Office Action Summary	Application No. 10/526,418	Applicant(s) SMIRTHWAITE ET AL.	
	Examiner ANN SCHILLINGER	Art Unit 3774

DETAILED ACTION

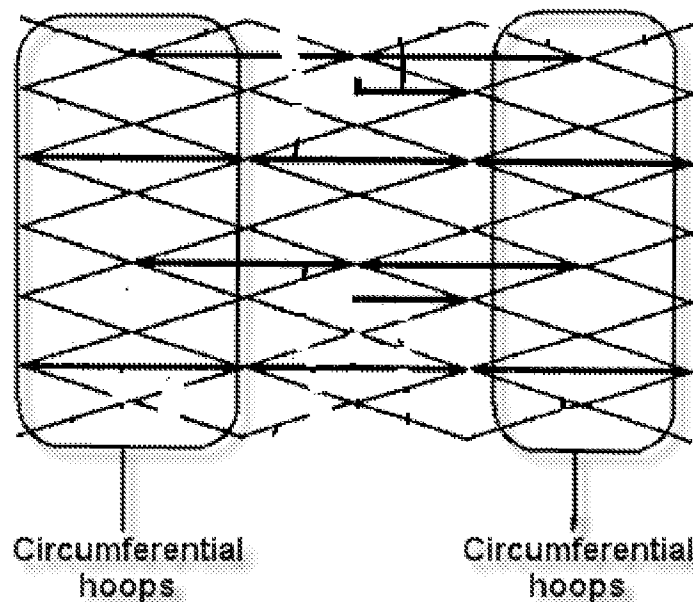
The Applicant also states that the second section 20 does not have separate, spaced circumferential hoops extending circumferentially around the longitudinal axis of the tubular

graft. The examiner respectfully disagrees. Please see the figure below for clarification as to how the prior art is being interpreted.
